I received addendum No. 01, Dated November 30, 2016 for
Oregon County BRO-B075(1)
Project Job #3479

ADDENDUM NO. 1

DATE: November 29, 2016

FOR: OREGON COUNTY BRIDGE REPLACEMENT
BRO-B075(1)
GRE NO. 3479

C.R. 225 BRIDGE OVER FREDERICK CREEK (BRO-B075(1))
OREGON COUNTY, MISSOURI

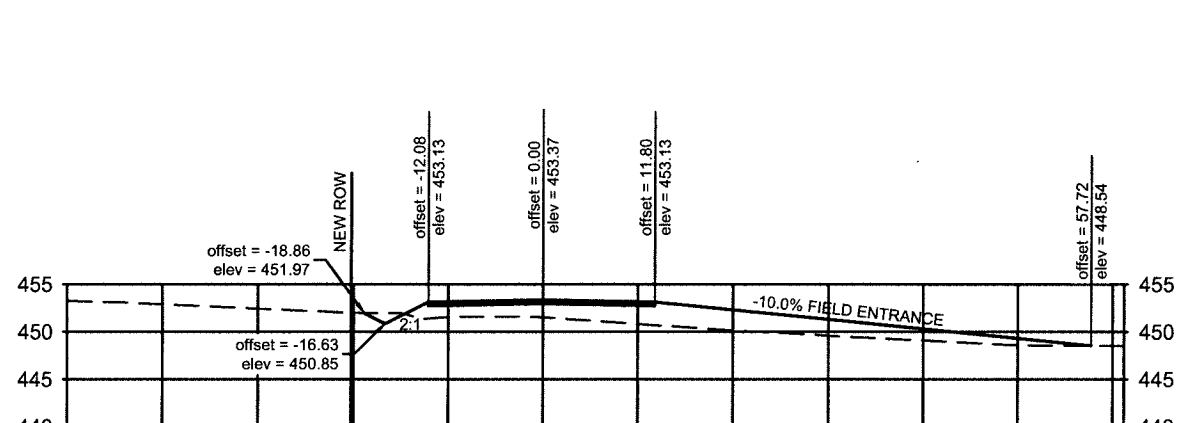
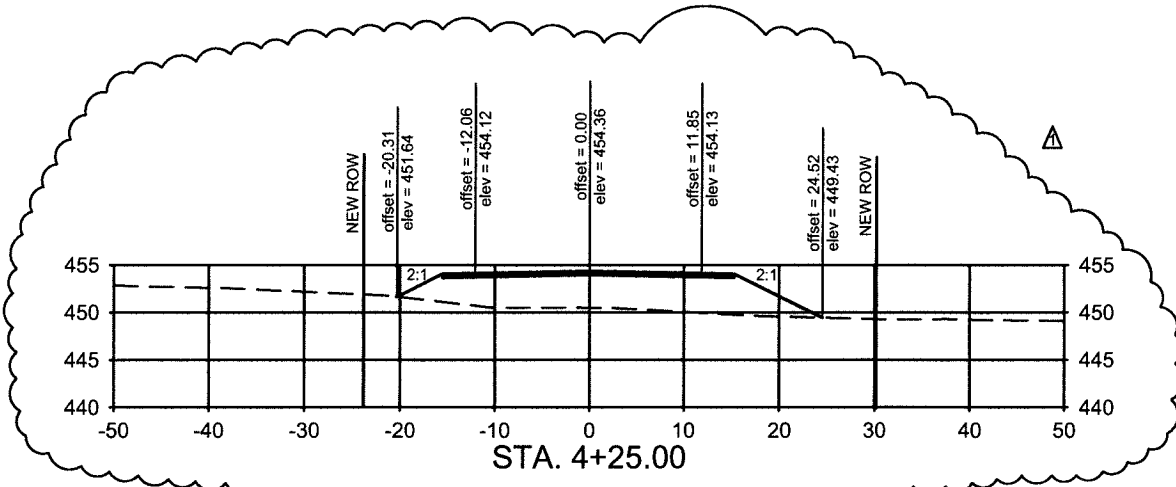
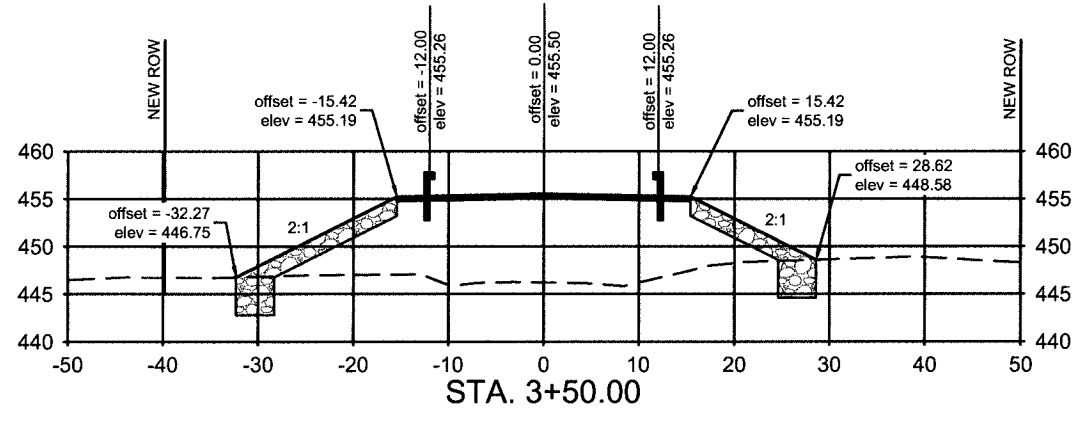
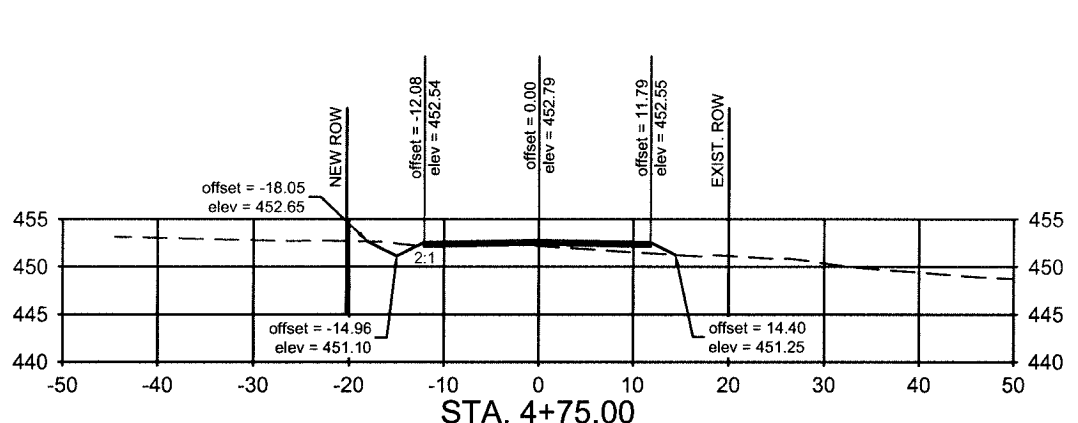
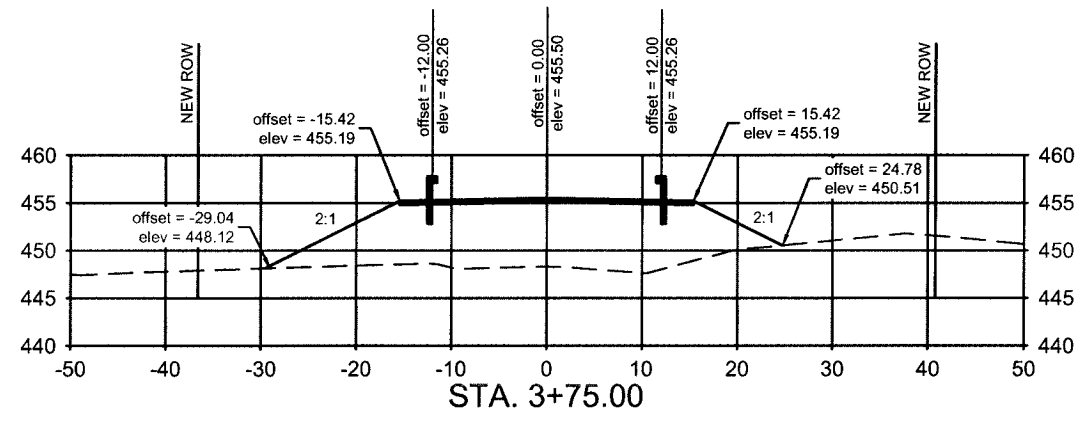
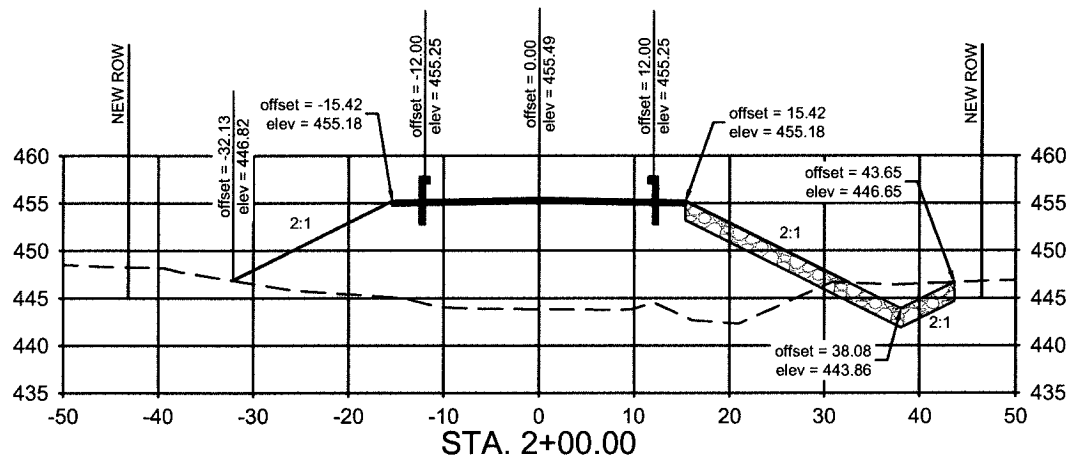
MASH End Terminals shall replace the Crashworthy End Terminal and a MGS Terminal Anchor End and Type A Guardrail shall be installed per the revised plans. Quantities have been revised due to these changes.

Date	Revision/Issue	No.
11-29-18	REVISED GUARDRAIL	1

C.R. 225 BRIDGE OVER FREDERICK CREEK (BRO-B075(1))
OREGON COUNTY, MISSOURI
CROSS SECTIONS

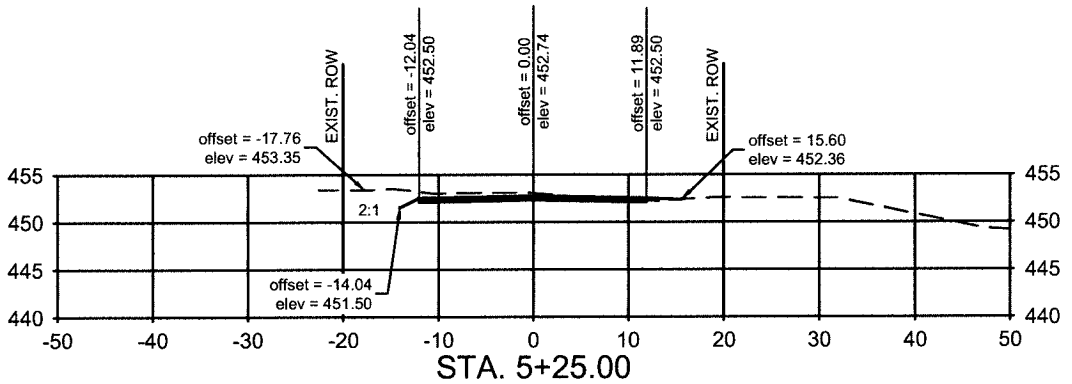
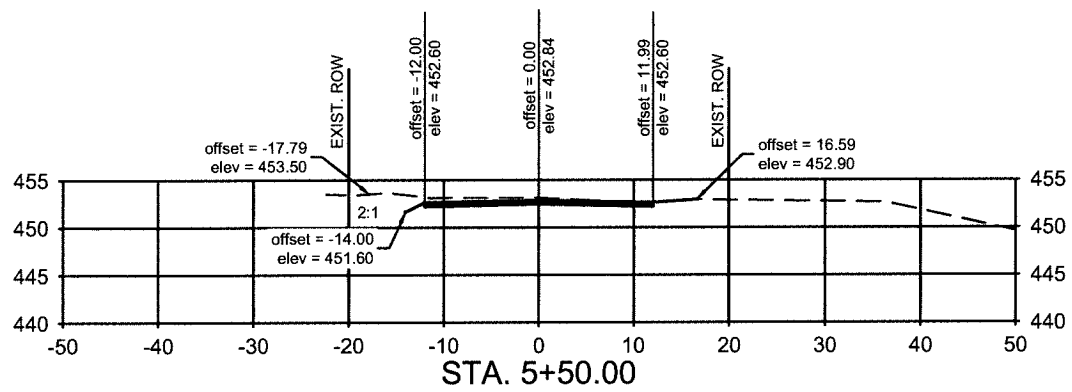
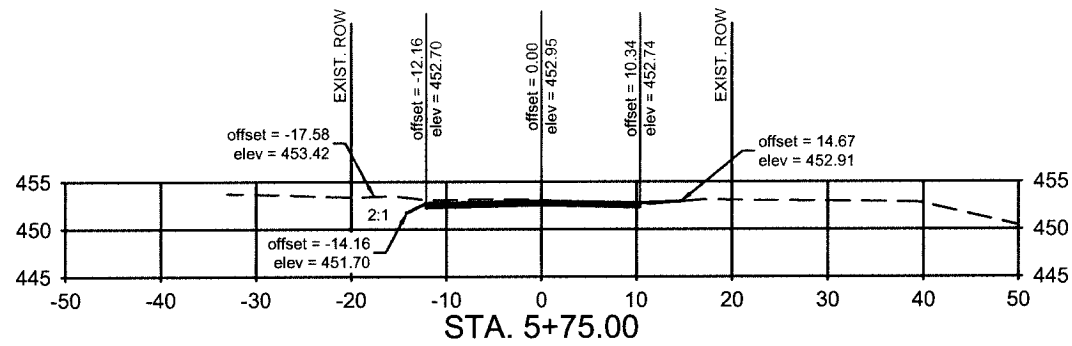
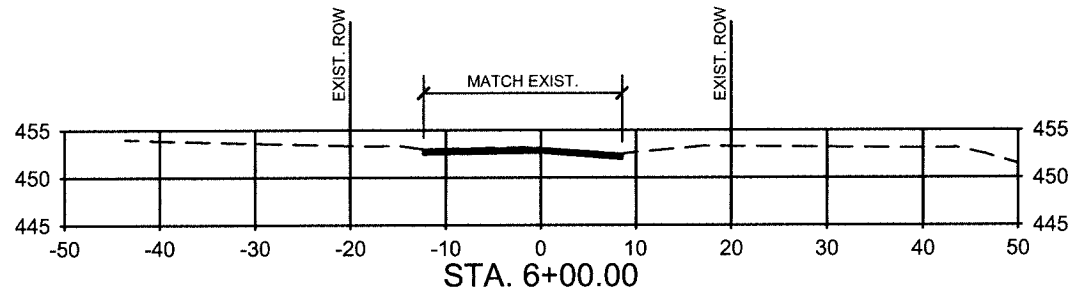
Date	Revision/Issue
11-28-18	REVISED GUARDRAIL
